# PERMIT

## SEWAGE DISPOSAL SYSTEM

HOWARD COUNTY HEALTH DEPARTMENT

SUBDIVISION Warfield's Estates LOT 31, Blk.C ROAD 14821 Burntwoods Road

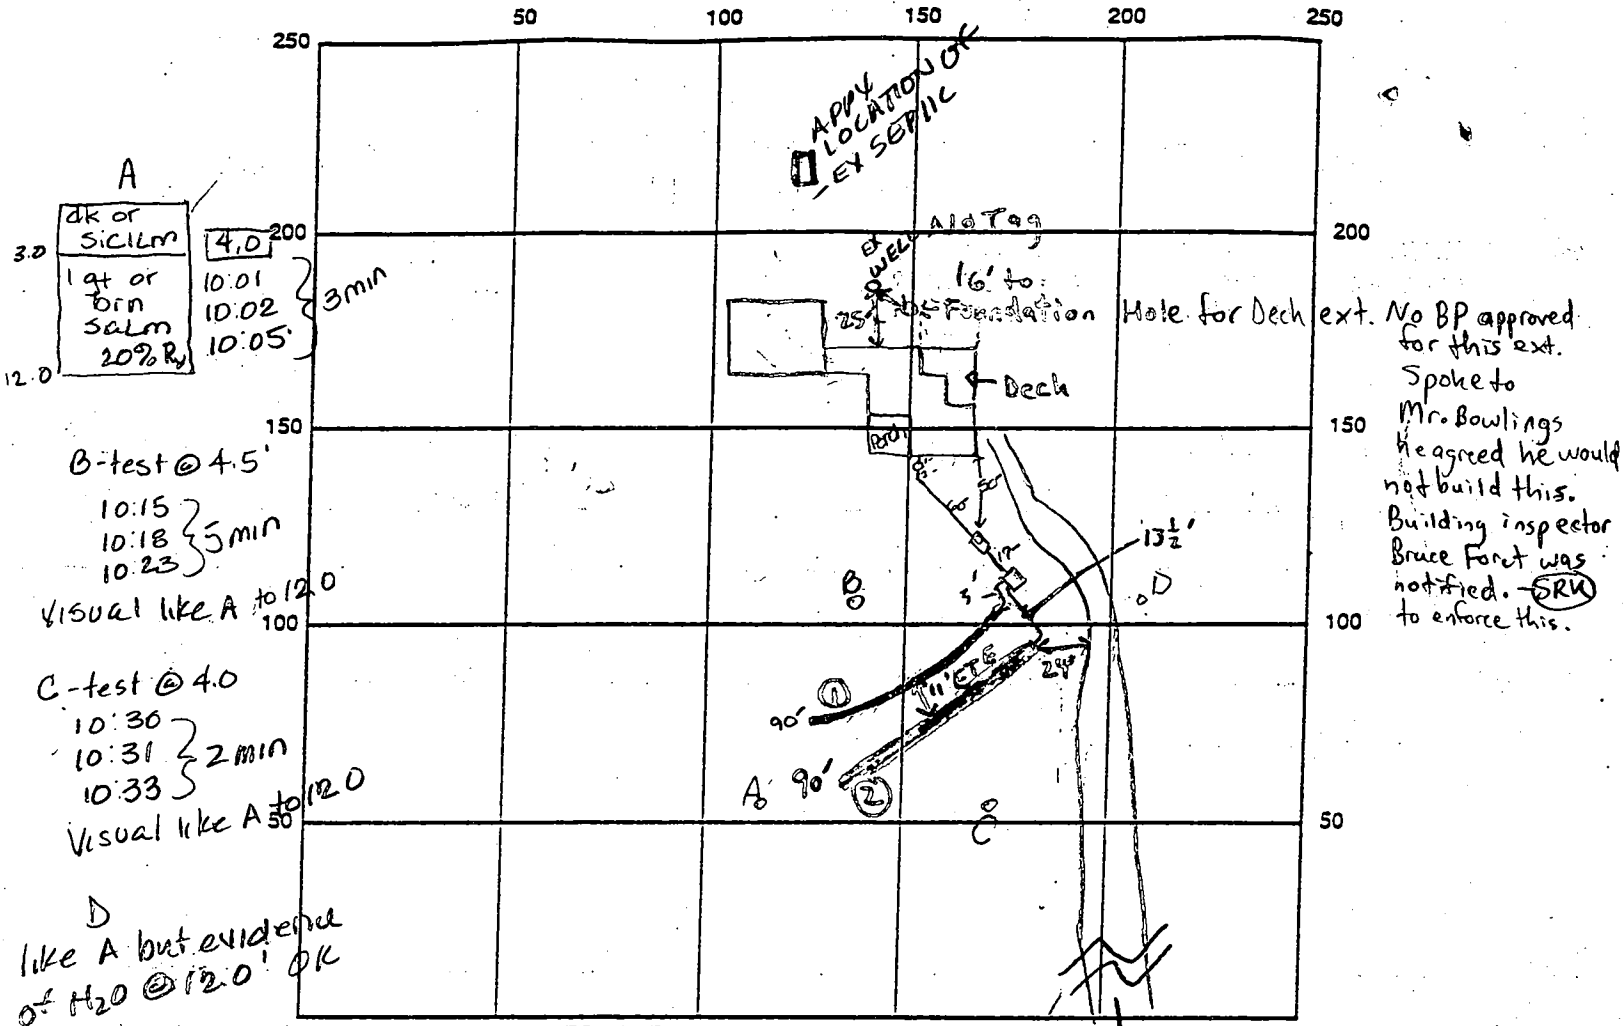
REPAIR - PURPOSE - IN SUPPORT OF FUTURE BUILDING PERMIT APPLICATION FOR A 3 BEDROOM ADDITION.  
Call for inspection when ground is opened so sanitarian can recommend repair.

Begin trenches @ test hole B - also abandon existing septic system  
@ time of repair AM

**A**  
 dk or Sicilm 4.0  
 1 qt or brn Salm 10:01  
 20% R<sub>0</sub> 10:02  
 10:05 } 3min

**B-test @ 4.5'**  
 10:15 }  
 10:18 } 5min  
 10:23 }

**C-test @ 4.0**  
 10:30 }  
 10:31 } 2min  
 10:33 }

**D**  
 like A but evidence of H<sub>2</sub>O @ 12.0' OK

REMARKS: 9/13/99 A.M. OK to cover from house to dist. box.  
OK to stone 1st trench and continue work. DCS  
9/13/99 p.m. OK to cover 1st trench and continue.  
(\* Owner may choose to maintain ex. system to serve ex. structure due to difficulty w/ plumbing issues \*) DCS  
9/14/99 - OK TO COVER ALL WORK - (SRK)
